NavData® Alert

Subject: Vancouver, British Columbia
Vancouver Intl (CYVR)
Vancouver Terminal Control Area (Class C) Airspace
Cycles 0909 & 0910

Incorrect Airspace Information

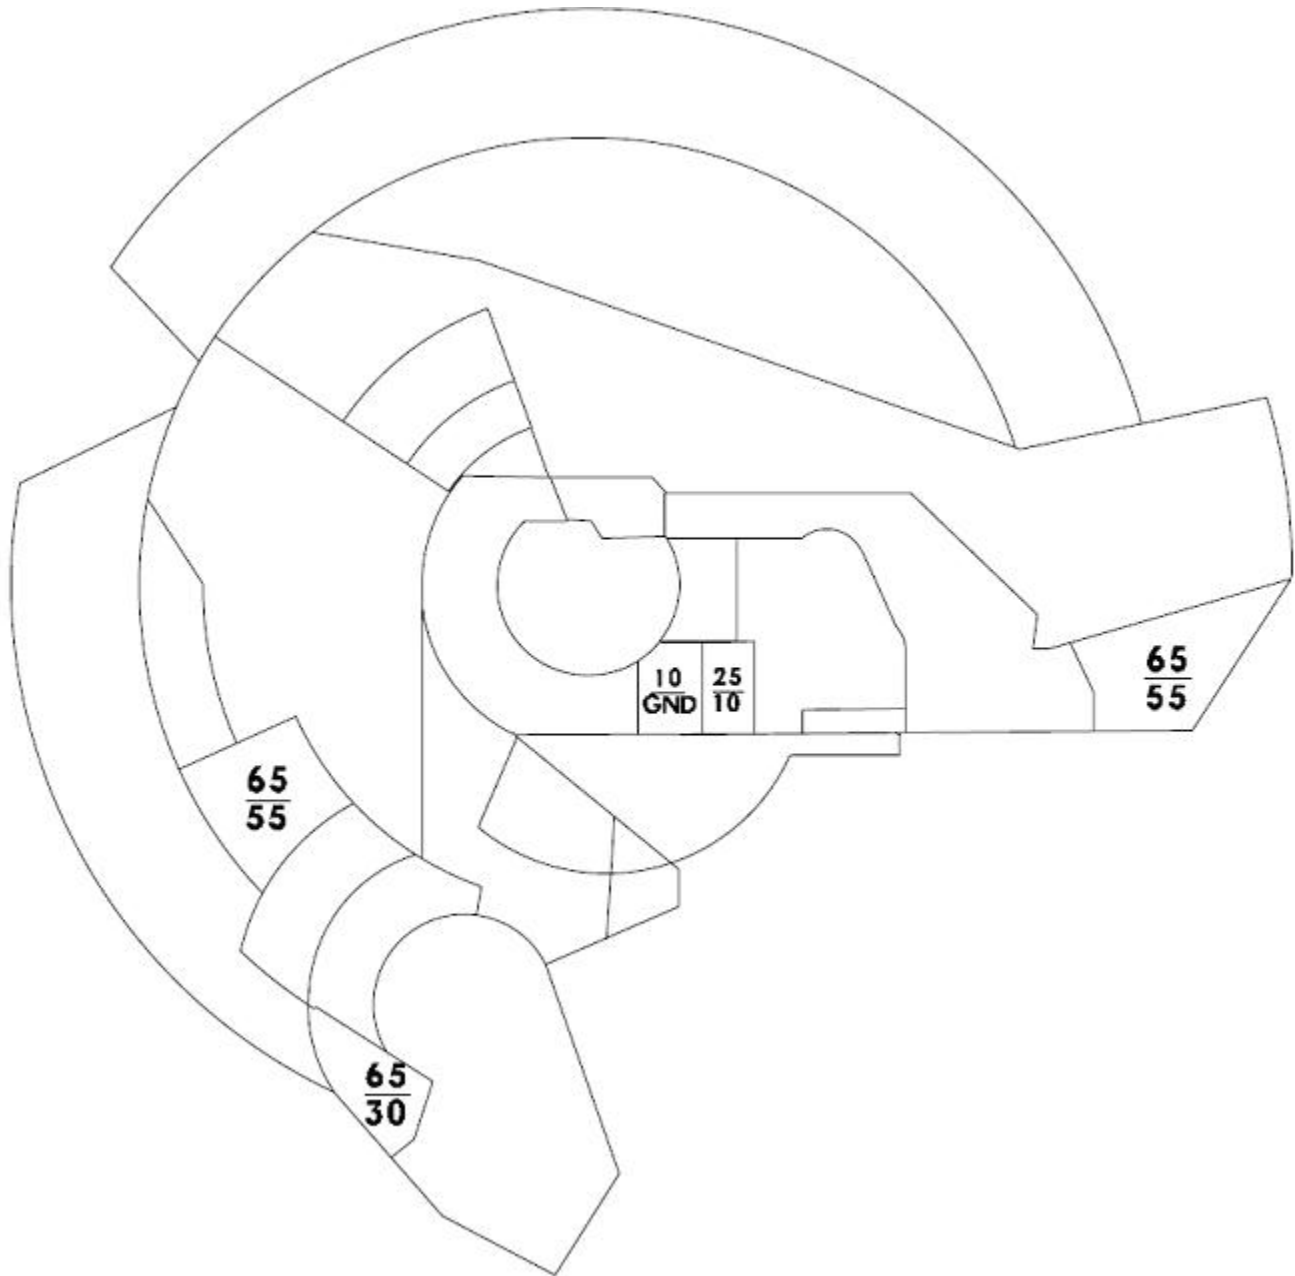
Jeppesen NavData for cycles 0909 and 0910, effective 27 August 2009 and 24 September 2009, respectively, contains incorrect lateral and vertical limits on certain sectors in the Vancouver Terminal Control Area (Class C) airspace; Vancouver, British Columbia (CYVR). The correct lateral and vertical information for Vancouver Terminal Control Area (Class C) airspace is depicted on the following page.

The following is a depiction of the corrected lateral and vertical limits for the Vancouver Terminal Control Area (Class C) airspace. The information for the airspace beneath and adjoining the Vancouver Terminal Control Area for other airports is correct and has not been depicted. Only revised altitudes that were incorrect in cycles 0909 & 0910 NavData have been shown.

Revised coding will appear in Jeppesen NavData for cycle 0911, effective 22 October 2009. Until then an entry will appear in the NavData Change Notices beginning 2 OCT 09, and this Alert will be posted on the Jeppesen Web site (<http://www.jeppesen.com/company/alerts/aviation-alerts.jsp?region=Canada%20%26%20Alaska>). Please refer to the Vancouver, British Columbia (CYVR) 10-1 chart dated 24 JUL 09 for valid information.
